# FINAL PLAT

## POWER C.D.C. THIRD ADDITION

RE: SUB 2003-13 -- One-Step Final Plat: Power C.D.C. Third Addition

**CASE NUMBER:** SUB 2003-13 -- POWER C.D.C. THIRD ADDITION

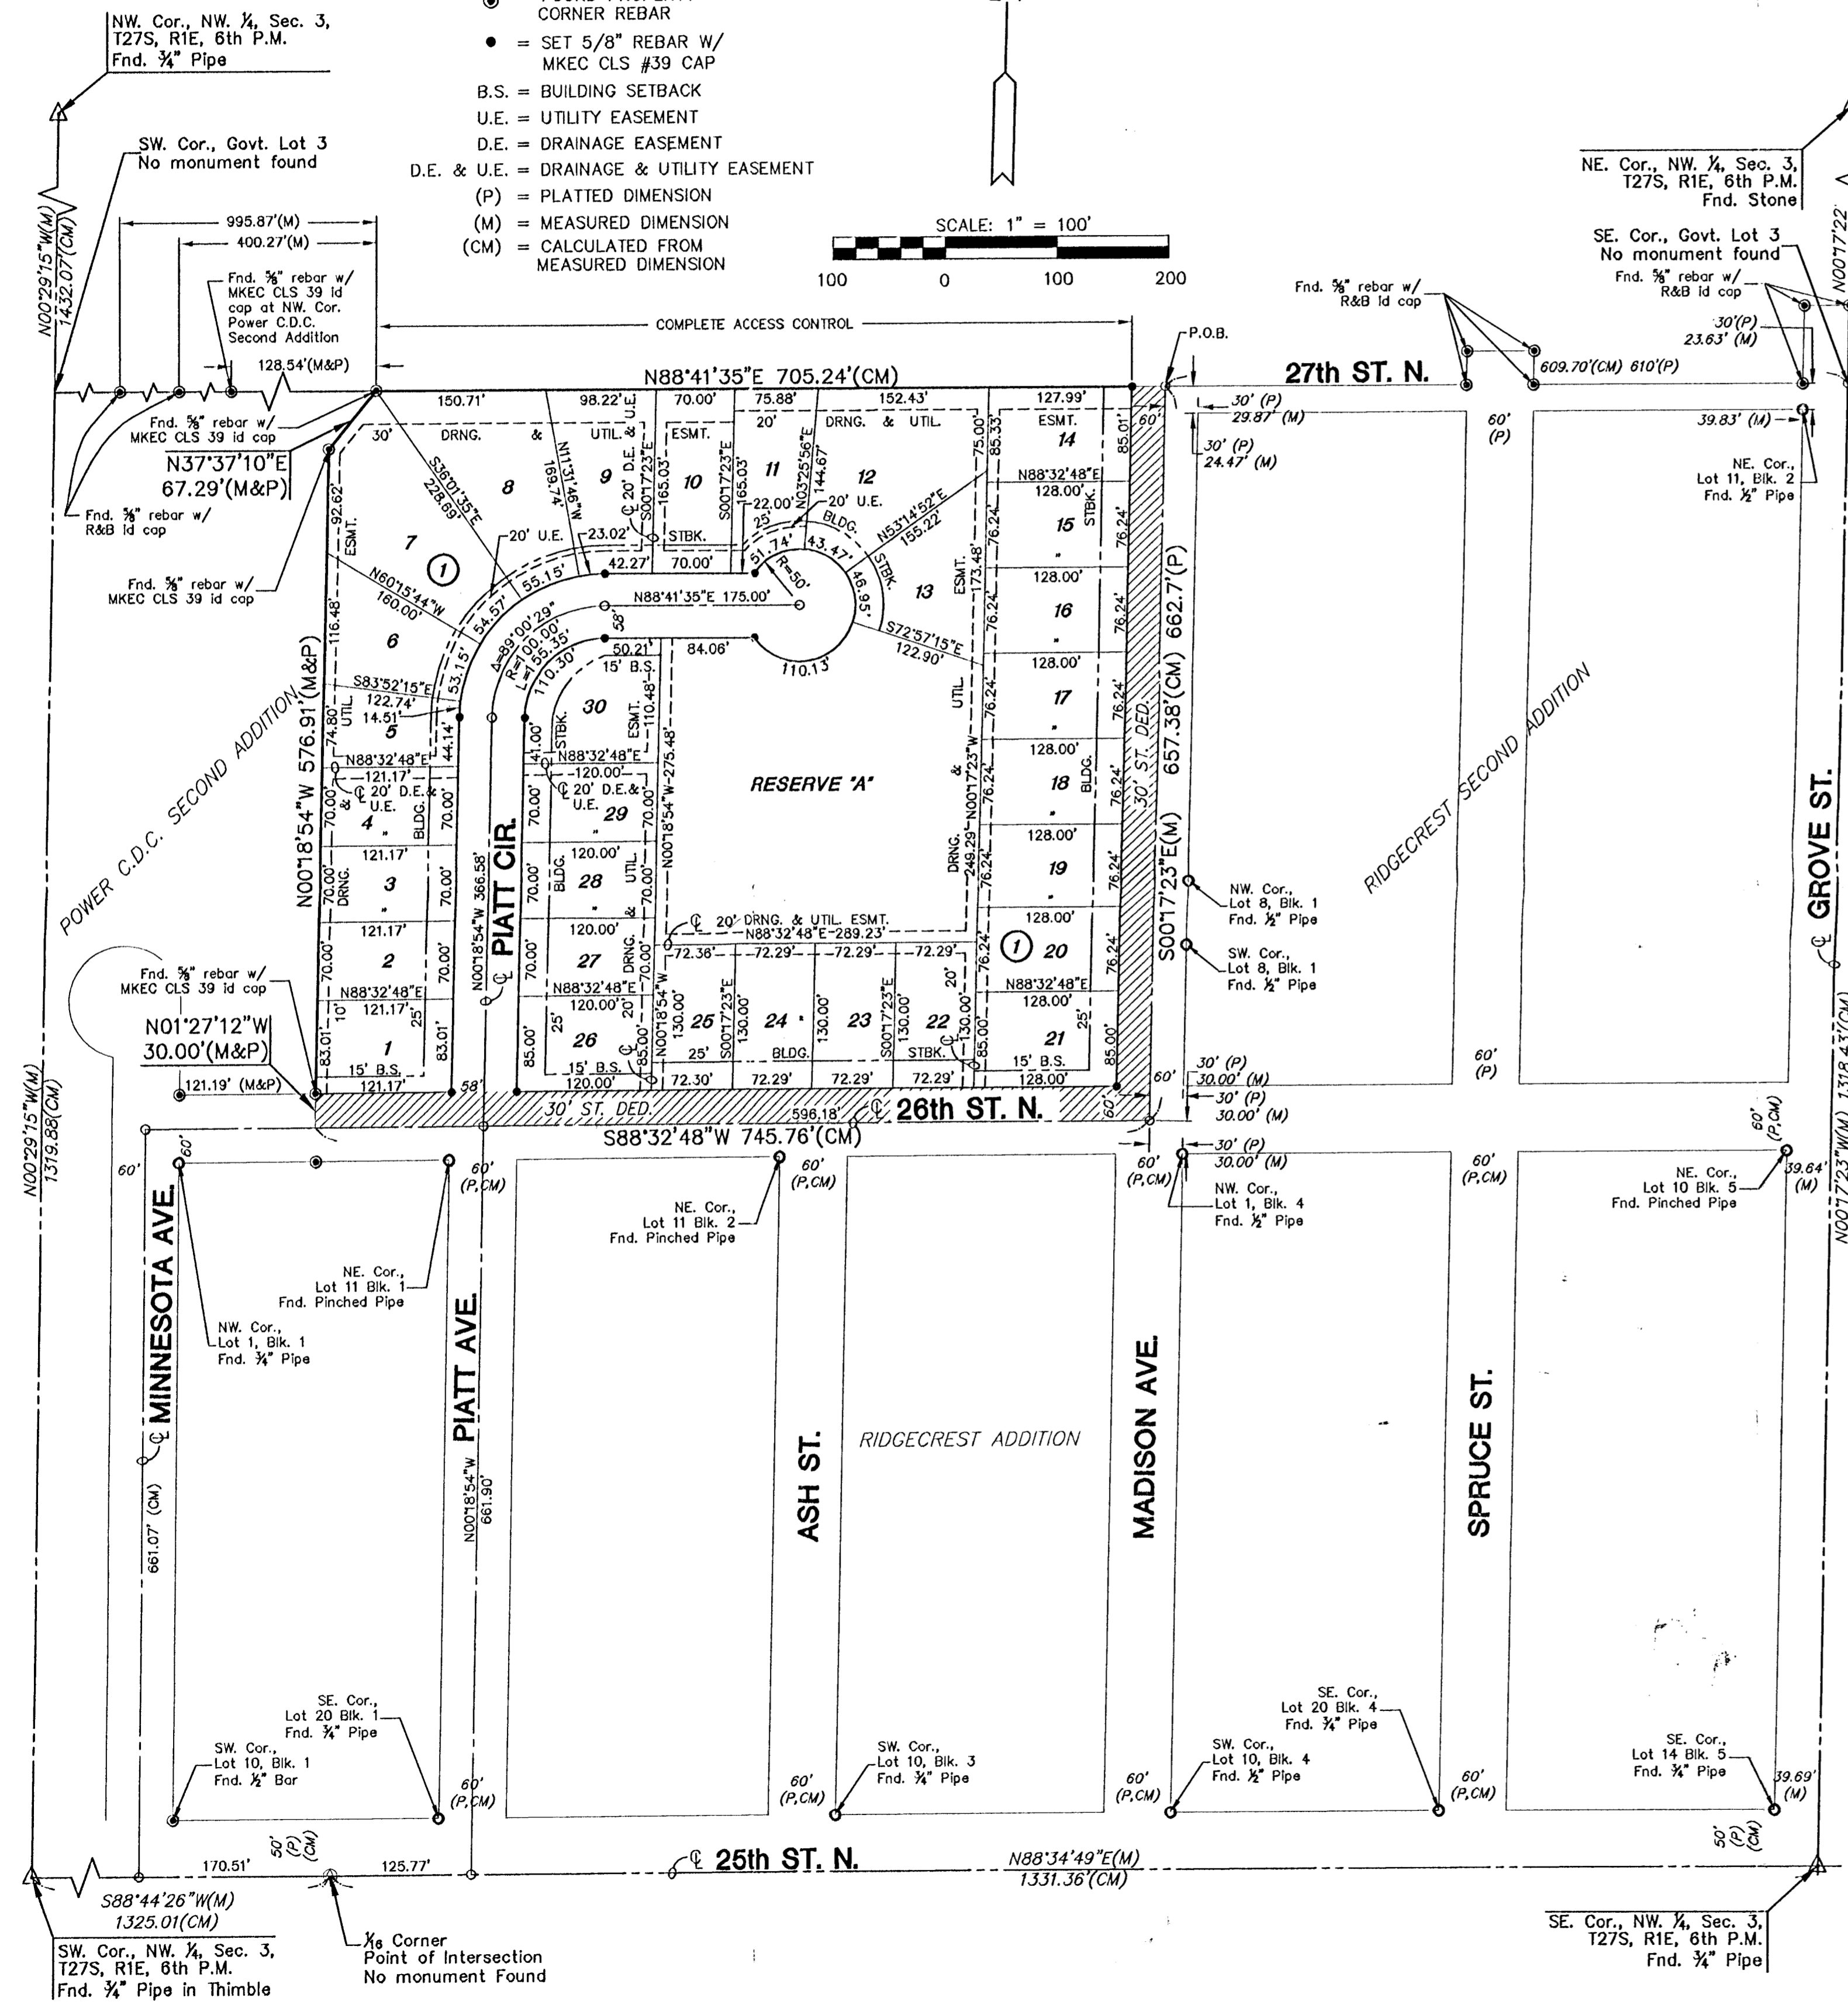
- A. The applicant shall guarantee the extension of sanitary sewer and City water to serve the lots being platted.
- B. If improvements are guaranteed by petition, a notarized certificate listing the petitions shall be submitted to the Planning Department for recording.

- C. **City Engineering** needs to comment on the status of the applicant's drainage plan. ***The drainage plan is approved.***
- D. The applicant shall guarantee the paving of the proposed interior streets in addition to 26<sup>th</sup> St. North and the west half of Madison.

- E. **Traffic Engineering** has requested complete access control to 27th Street.
- F. Provisions shall be made for ownership and maintenance of the proposed reserves. The applicant shall either form a lot owners' association prior to recording the plat or shall submit a covenant stating when the association will be formed, when the reserves will be deeded to the association and who is to own and maintain the reserves prior to the association taking over those responsibilities.

- G. The applicant shall submit a covenant which provides for four (4) off-street parking spaces per dwelling unit on each lot which abuts a 58-foot street. The covenant shall inventory the affected lots by lot and block number and shall state that the covenant runs with the land and is binding on future owners and assigns.

- H. The City Fire Department/GIS needs to comment on the plat's street names. *The street names are approved.*
- I. On the final plat tracing, the MAPC signature block needs to reference "Bernard A. Hentzen, Chair".

- J. City Environmental Health has requested that a restrictive covenant be recorded that prohibits the use of water wells on the site for any purpose.

- L. The platting text shall include language that a drainage plan has been developed for the plat and that all drainage easements, rights-of-way, or reserves shall remain at established grades or as modified with the approval of the applicable City or County Engineer, and unobstructed to allow for the conveyance of stormwater.

- R. Perimeter closure computations shall be submitted with the final plat tracing.
- S. Recording of the plat within thirty (30) days after approval by the City Council and/or County Commission.
